Agenda
Village of Arlington Heights
Design Commission
Commissions Room 2nd Floor

Arlington Heights Village Hall
33 S. Arlington Heights Road
Arlington Heights, IL 60005
November 15, 2016
6:30 PM

MINUTES OF
THE VILLAGE OF ARLINGTON HEIGHTS
DESIGN COMMISSION MEETING
HELD AT THE ARLINGTON HEIGHTS MUNICIPAL BUILDING
33 S. ARLINGTON HEIGHTS RD.
OCTOBER 25, 2016

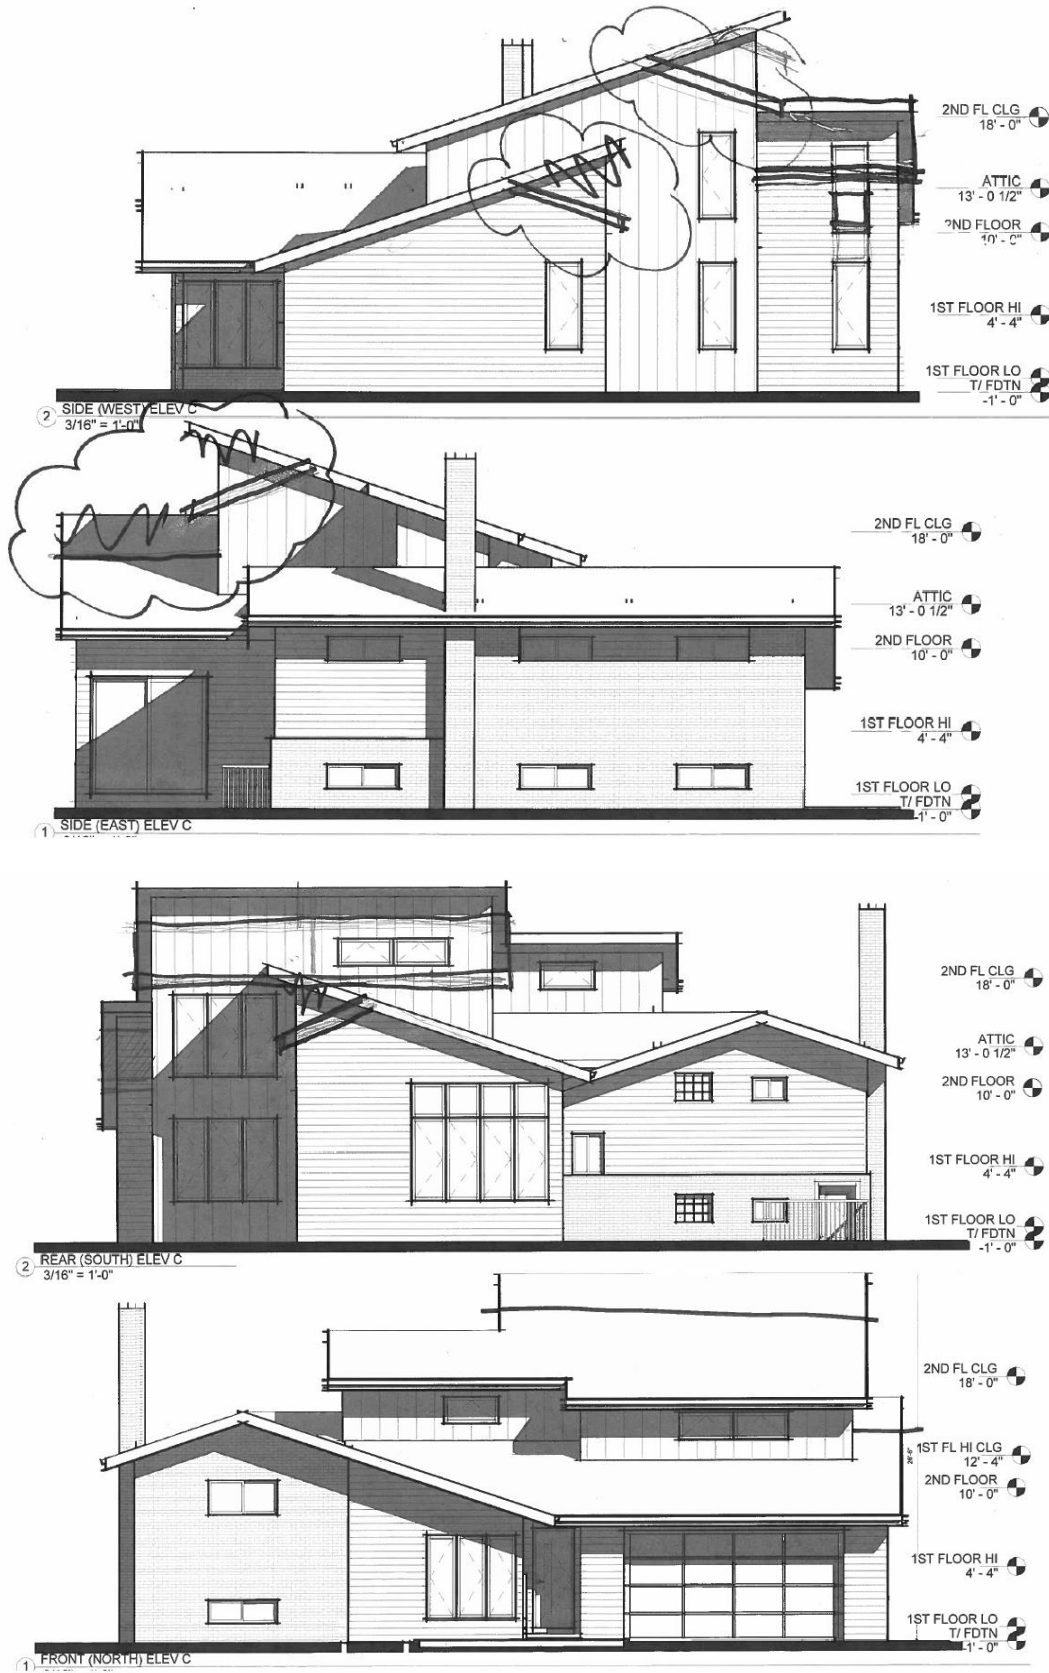
The proposed addition is a nicely planned expansion to the existing, modern style, split level home, and the front elevation looks good. However, the concern with the design is the proposed single-slope shed roof forms that create large and tall walls on the side and rear elevations. The tall sloping roofs and tall walls are not in context with the existing house or the neighborhood. Per the Village of Arlington Heights' Single-Family Design Guidelines, additions should look like they belong and not dominate or change the character of the original building, and designs must also be evaluated with the architectural character of the neighborhood.

It is recommended that the shed roof forms be changed to asymmetrical gables which will tie in very nicely with the asymmetrical gable on the existing house as well as other homes in the neighborhood. Additionally, changing the roof as recommended will also address the building height concern. The sketches below illustrate the recommended revisions:

1. Change the shed roof forms to asymmetrical gables with the highest midpoint no more than 25 feet tall as illustrated in the attached sketches.
2. This review deals with architectural design only and should not be construed to be an approval of, or to have any other impact on, any other zoning and/or land use issues or decisions that stem from zoning, building, signage or any other reviews. In addition to the normal technical review, permit drawings will be reviewed for consistency with the Design Commission and any other Commission or Board approval conditions. It is the architect/homeowner/builder's responsibility to comply with the Design Commission approval and ensure that building permit plans comply with all zoning code, building permit and signage requirements.
3. Compliance with all applicable Federal, State, and Village codes, regulations and policies.

1 FRONT (NORTH) ELEV PROPOSED
1/4" = 1'-0"

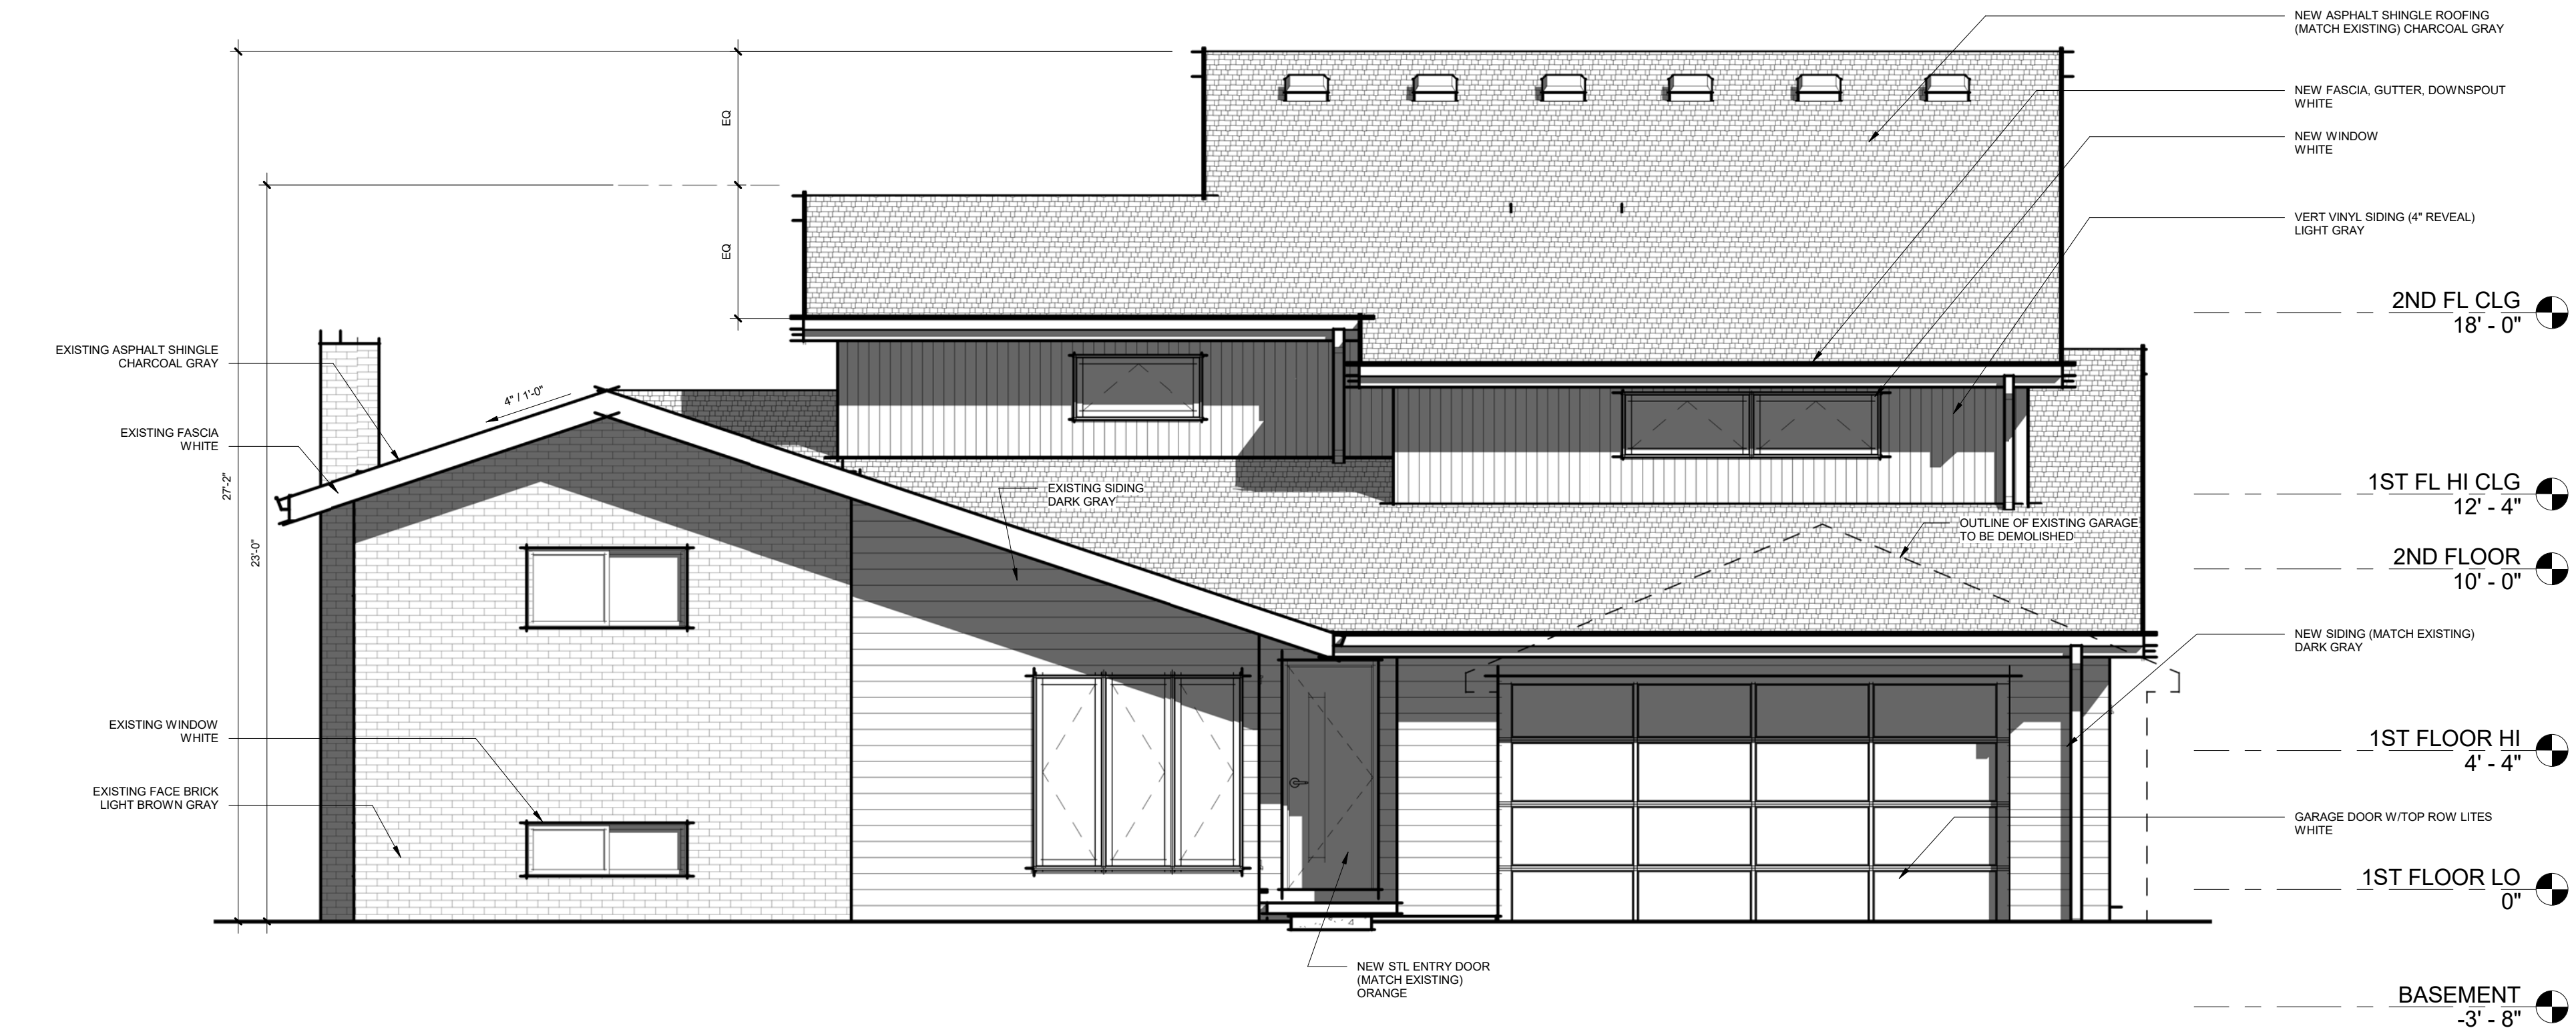
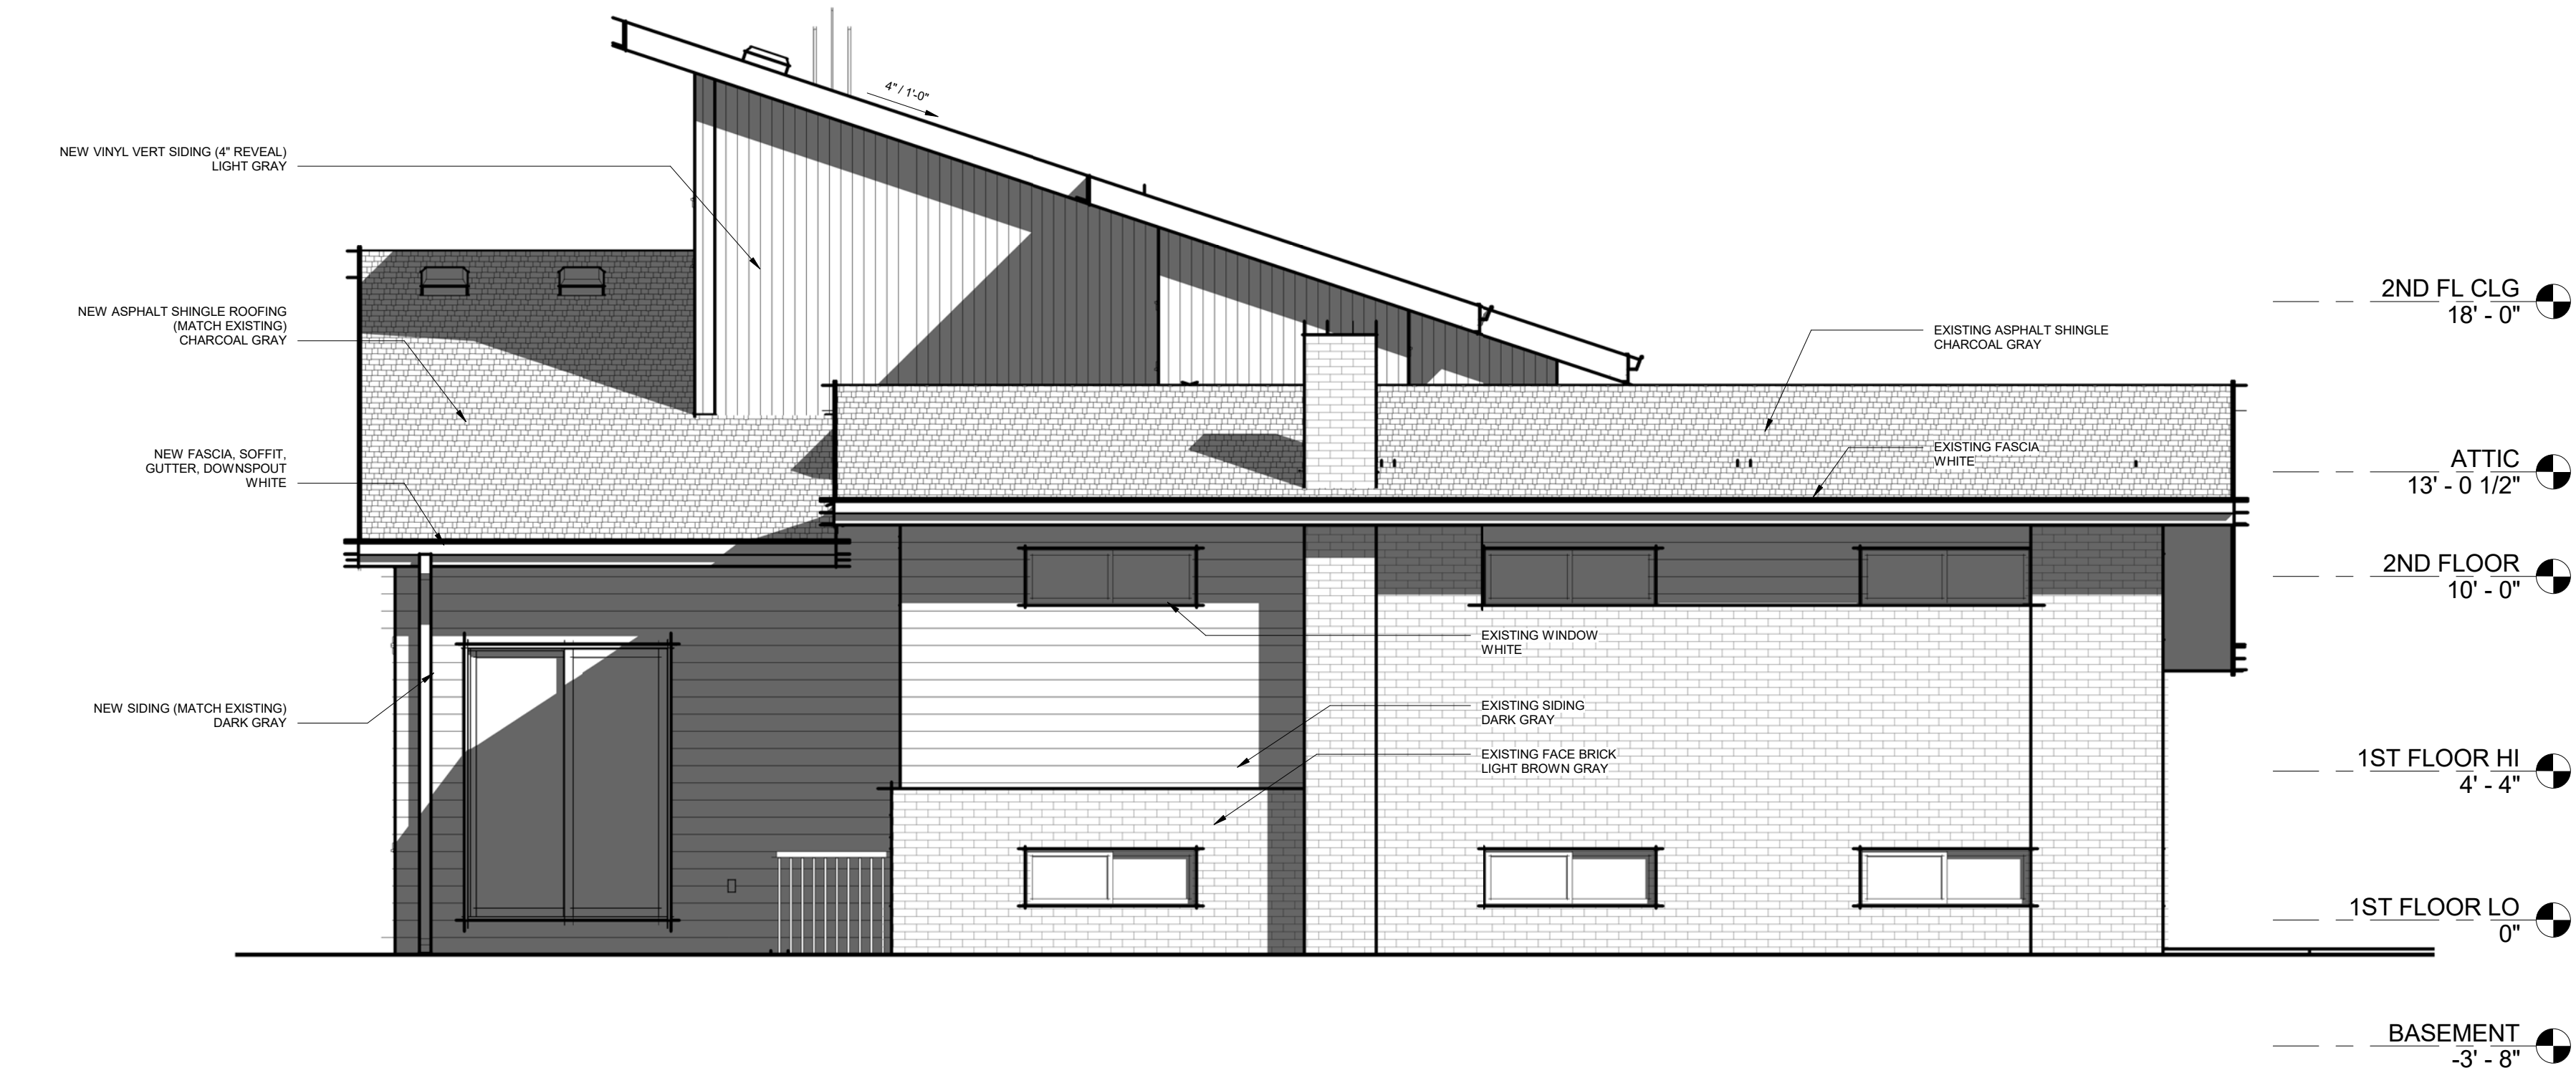
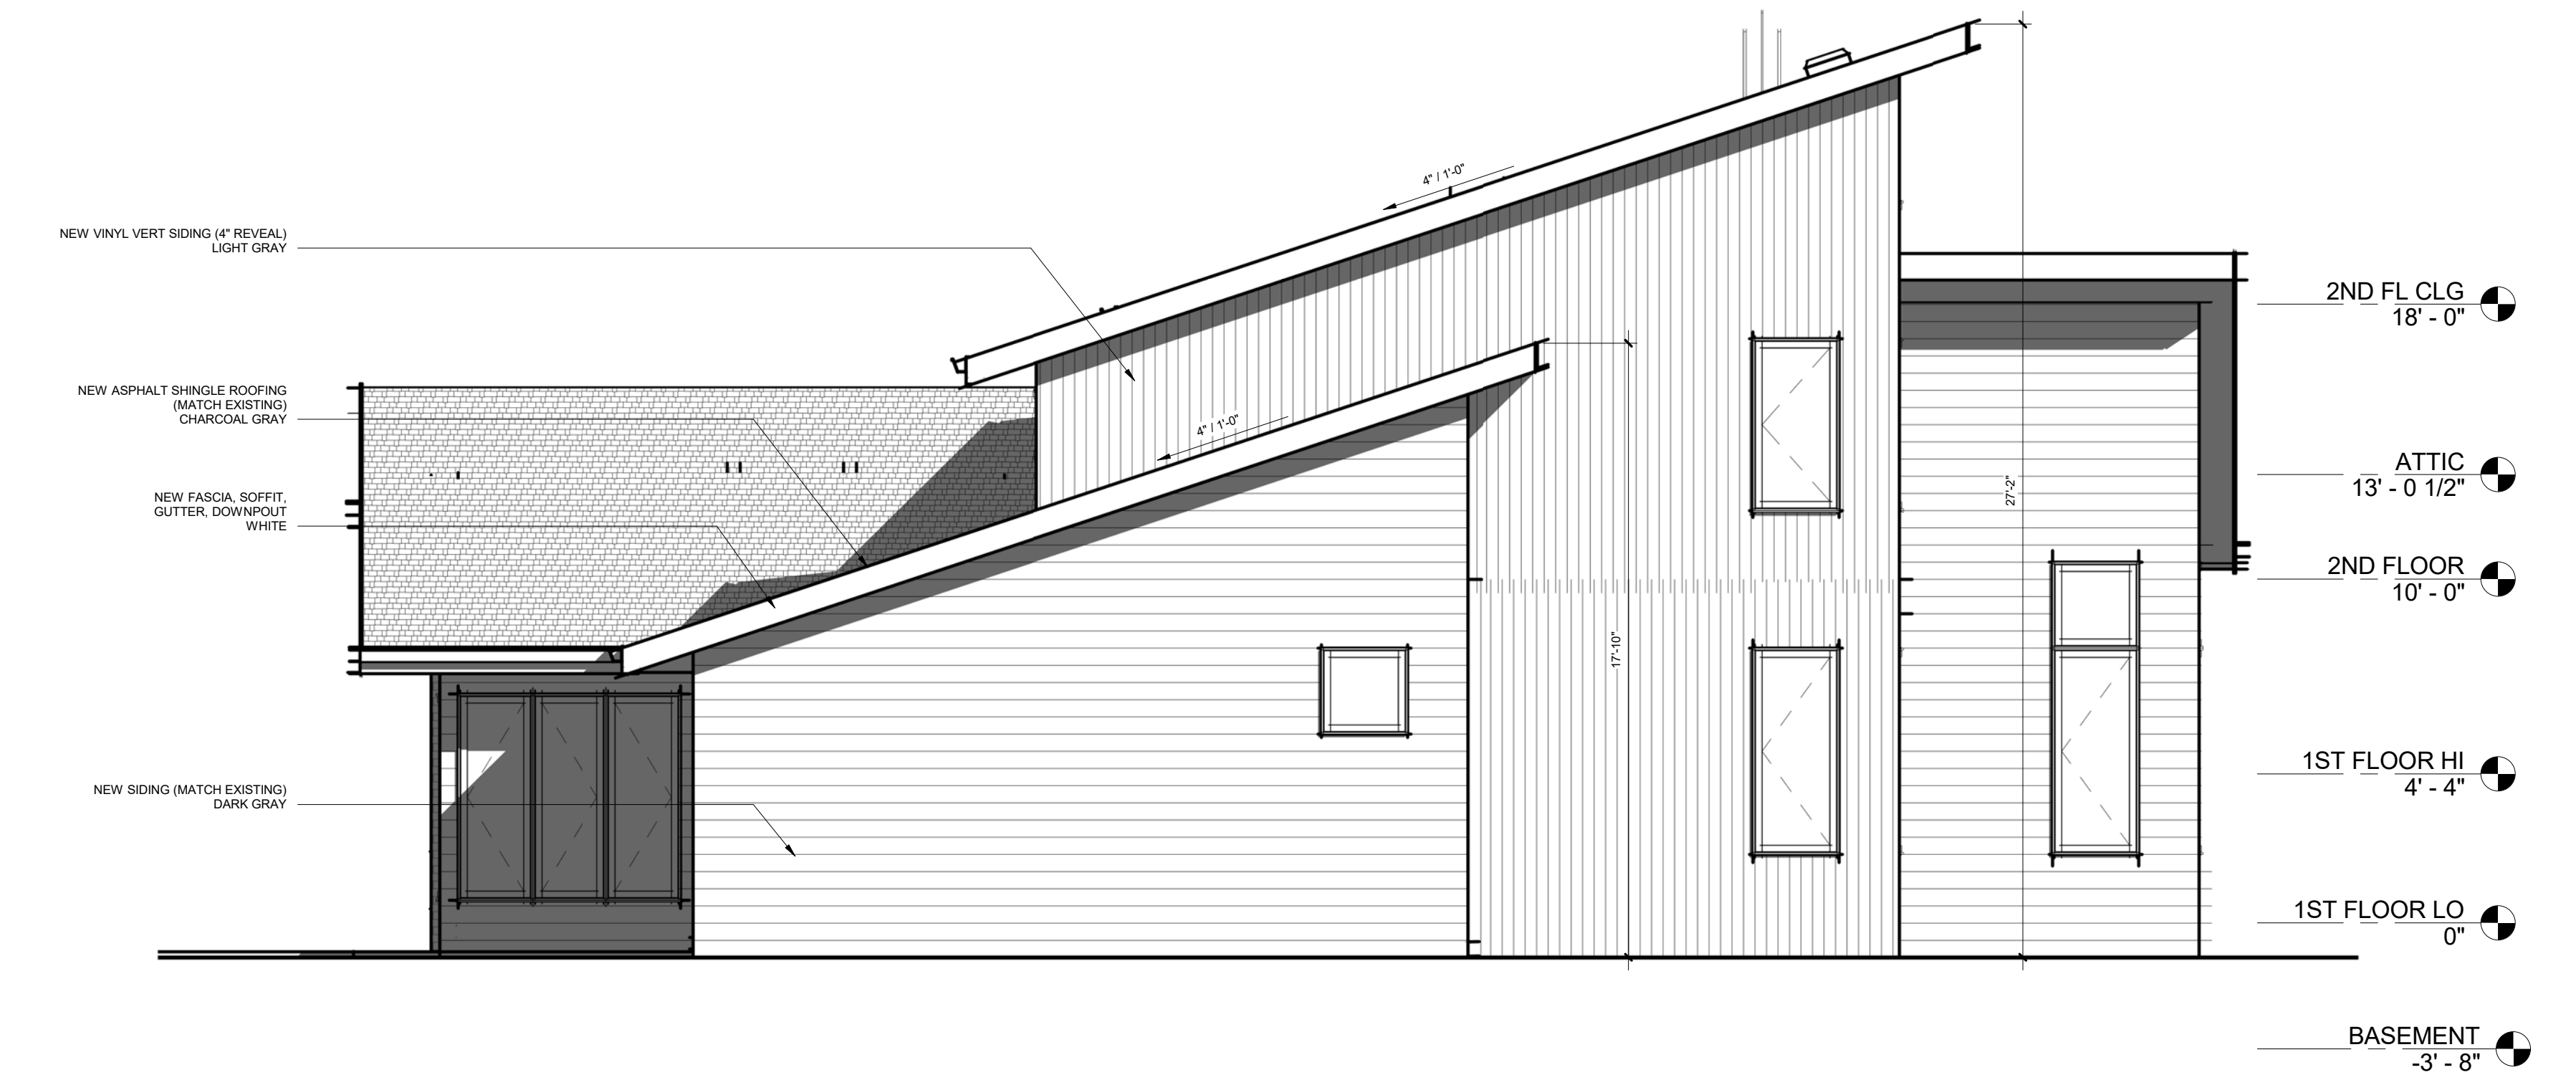
1. Change the shed roof forms to asymmetrical gables with the highest midpoint no more than 25 feet tall as illustrated in the attached sketches.
2. This review deals with architectural design only and should not be construed to be an approval of, or to have any other impact on, any other zoning and/or land use issues or decisions that stem from zoning, building, signage or any other reviews. In addition to the normal technical review, permit drawings will be reviewed for consistency with the Design Commission and any other Commission or Board approval conditions. It is the architect/homeowner/builder's responsibility to comply with the Design Commission approval and ensure that building permit plans comply with all zoning code, building permit and signage requirements.
3. Compliance with all applicable Federal, State, and Village codes, regulations and policies.
